CITY OF OREGON CITY HISTORIC REVIEW BOARD AGENDA

1. GLUA-20-000043 and HR 20-00009: Historic Review for a new single family home and detached garage in the Canemah National Register District at 616 4th Avenue

Staff Report

GLUA-20-000043 and HR 20-00009: Historic Review for a new single family home and detached garage in the Canemah National Register District at 616 4th Avenue

Site Plan

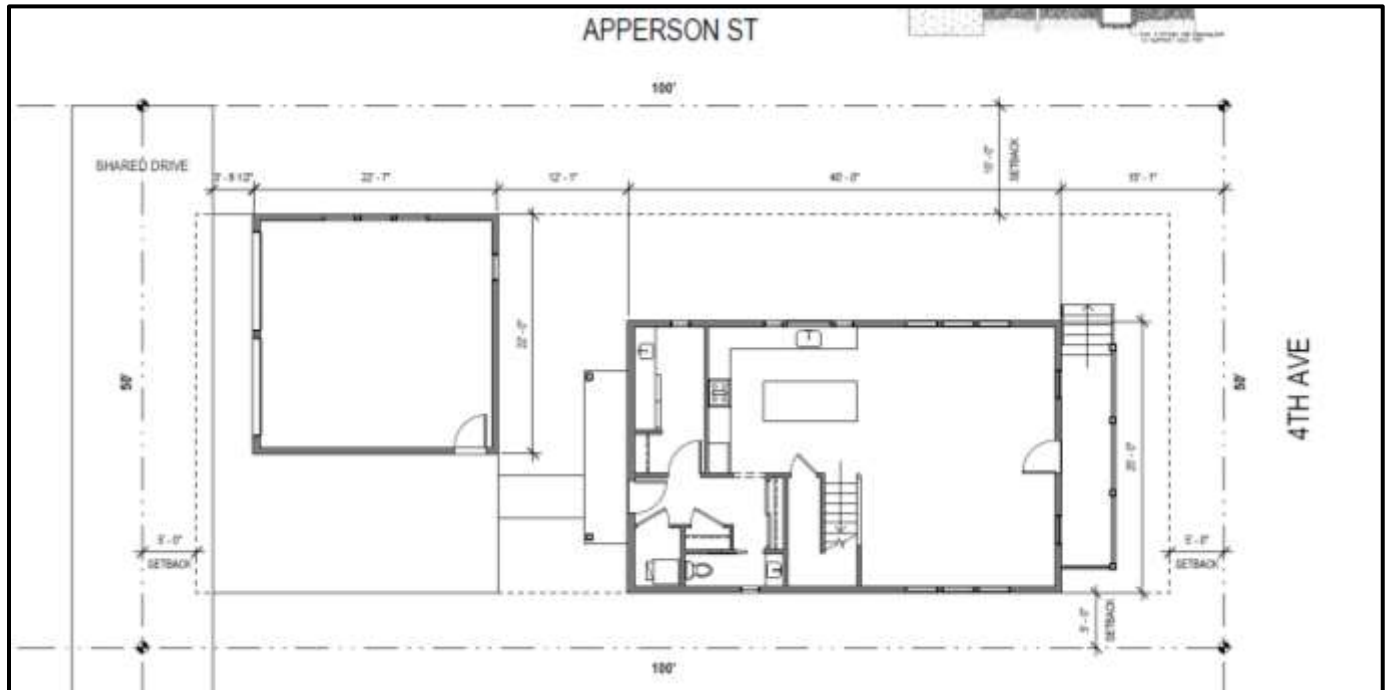
The design guidelines state that houses closer than 15 feet to the lot line require visual screening from one another. The proposed home is 5 feet from the property line on the east side where another lot of record (Lot 3) exists and where the applicant plans to build another home in the future. The applicant shall add landscaping to screen the home on the east side including at least two trees and six shrubs. These plantings may occur on the neighboring lot (Lot #3, which is under the same ownership currently)

if desired, and may be added at the time of future construction of a home on Lot 3, or within two years of a final certificate of Occupancy for the home, whichever is earlier.

1. The applicant shall add landscaping to screen the home on the east side including at least two trees 1.4" caliper or greater and six shrubs. These plantings may occur on the neighboring lot (Lot #3, which is under the same ownership currently) if desired, and may be added at the time of future construction of a home on Lot 3, or within two years of a final certificate of Occupancy for the home, whichever is earlier. (P)

Front elevation

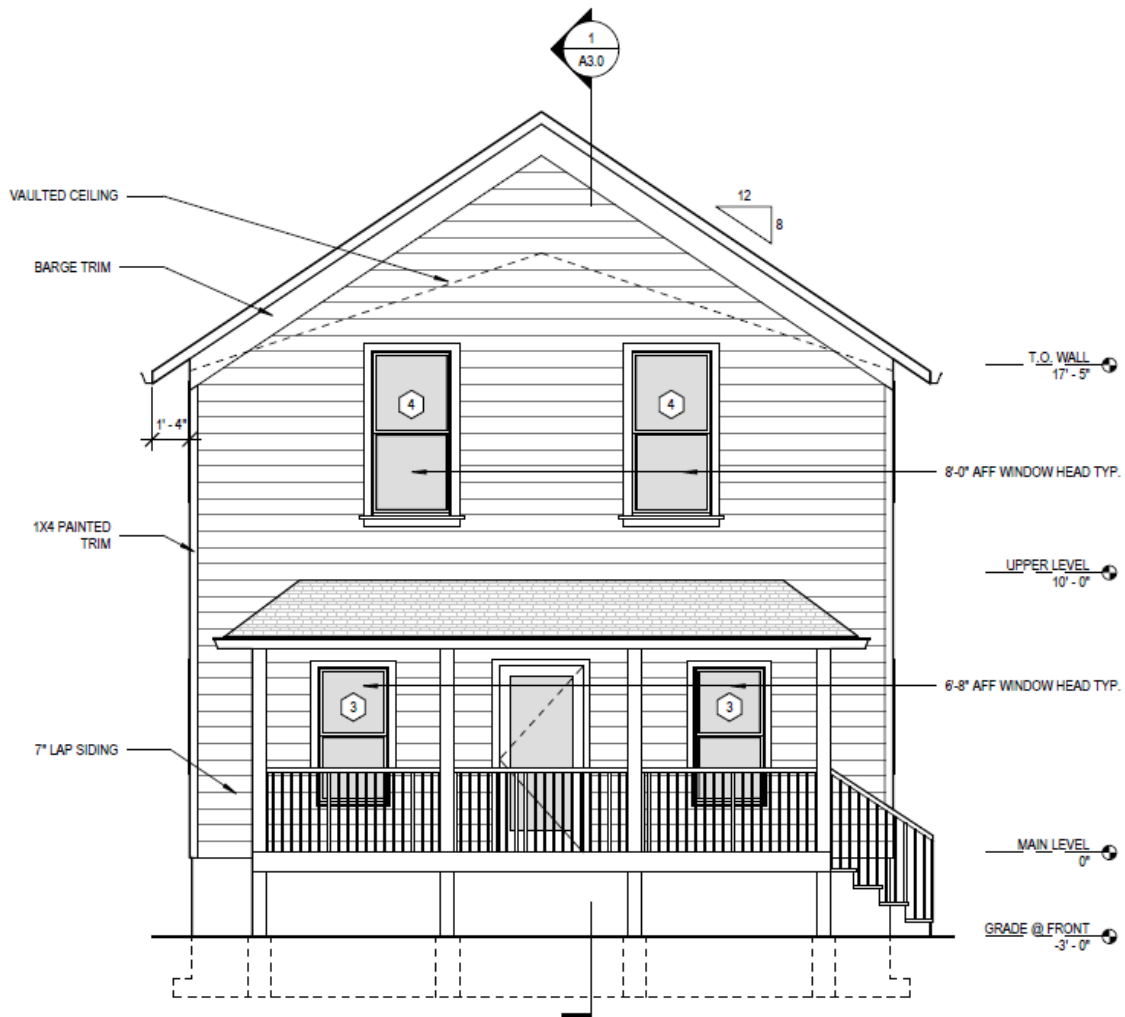
The plans show an additional 2'4" feet in height of mass underneath the front porch. Landscaping in the form of 5 shrubs should be added to visually shield the massing. The applicant shall plant no less than 5 shrubs in front of the home along the foundation.

The home has a hip roofed porch to help break down the overall scale of the building. The porch columns are simple untapered design. **The porch rail shall include top and bottom rail with balusters interior to the rail.** The area under the front porch (about 2 feet 4" of vertical distance) is not shown with any material or design detail on the applicant's plan. **The applicant shall use perpendicular wood lattice, horizontal siding, or another material specifically approved by the Board.**

The exterior is proposed to be covered with 7" reveal fiber cement lap siding, with 1x4" painted trim and a 12" barge board. **The applicant shall change the siding to smooth rather than textured fiber cement siding.**

5. The applicant shall plant no less than 5 shrubs in front of the home along the foundation. (P)
6. The applicant shall utilize simple vernacular styled exterior lighting.(P)

Garage elevations

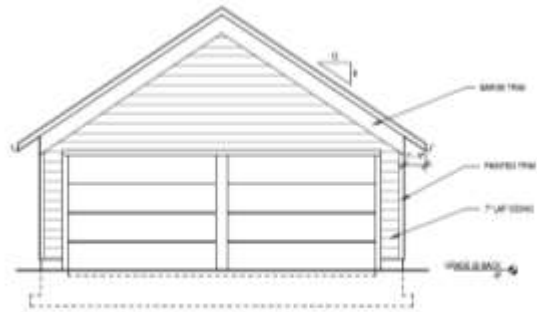
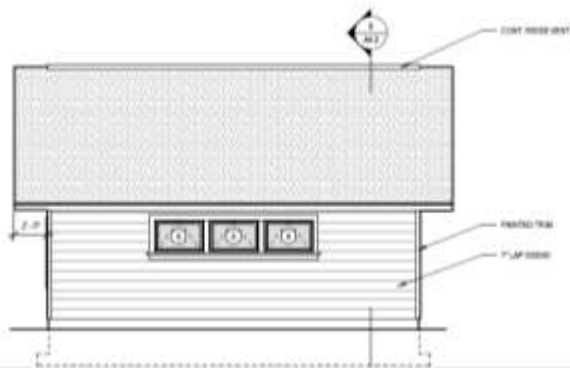
The garage behind the home is proposed with a 500 sf footprint. The height of the garage is less than the home. The garage is proposed 10 feet from the side property line and about 10 feet from the rear property line. Because the garage is larger than historic garage volumes, the applicant shall be required to screen it with landscaping. Prior to issuance of a final certificate of occupancy, the applicant shall plant at least two trees 1.5" caliper minimum (at least one conifer) and at least four shrubs to screen the garage from 4th Avenue and Apperson Street.

Because the garage is larger than historic garage volumes, the applicant shall be required to screen it with landscaping. Prior to issuance of a final certificate of occupancy, the applicant shall plant at least two trees 1.5" caliper minimum (at least one conifer) and at least four shrubs to screen the garage from 4th Avenue and Apperson Street.

2. Prior to issuance of a final certificate of occupancy, the applicant shall plant at least two trees 1.5" caliper minimum (at least one conifer) and at least four shrubs to screen the garage from 4th Avenue and Apperson Street. (P)

1 SOUTH ELEVATION
1/4" = 1'-0"

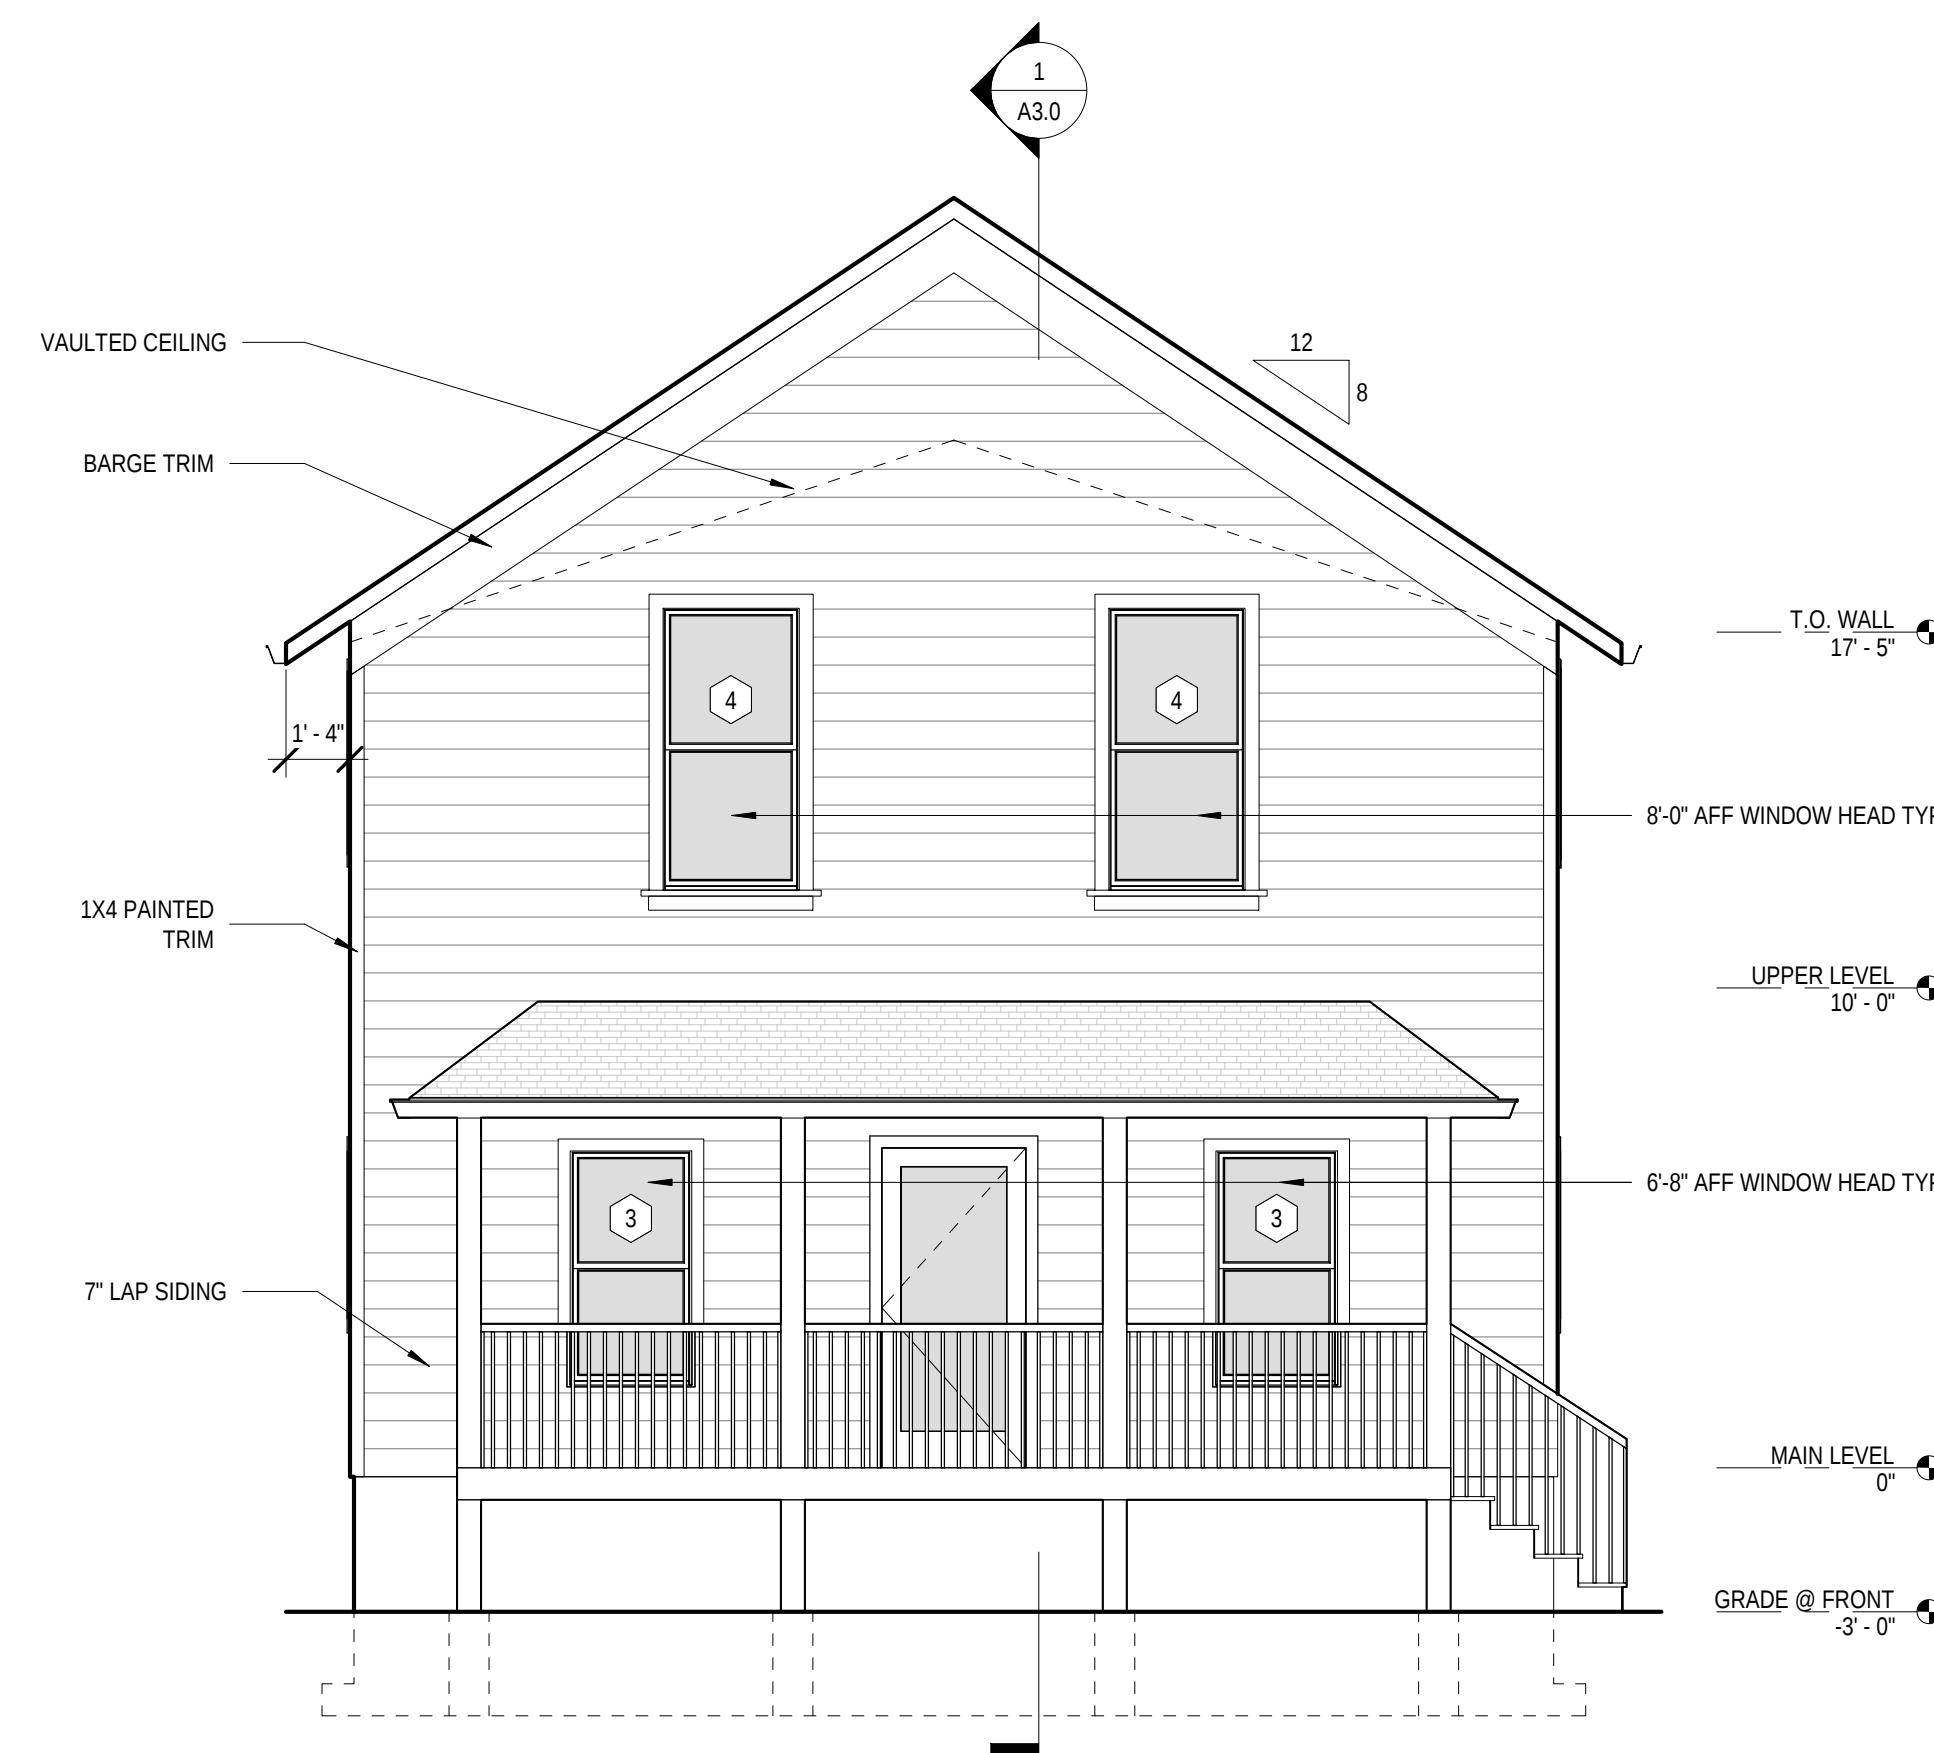
A comment from Jane Shull that the plans on the Notice of Public Hearing shows the front of the proposed house on 4th Ave labeled as "South Elevation", which is incorrect.

The Notice of Public Hearing shows the front of the proposed house on 4th Ave labeled as “South Elevation” - the plans in the website have similar errors.
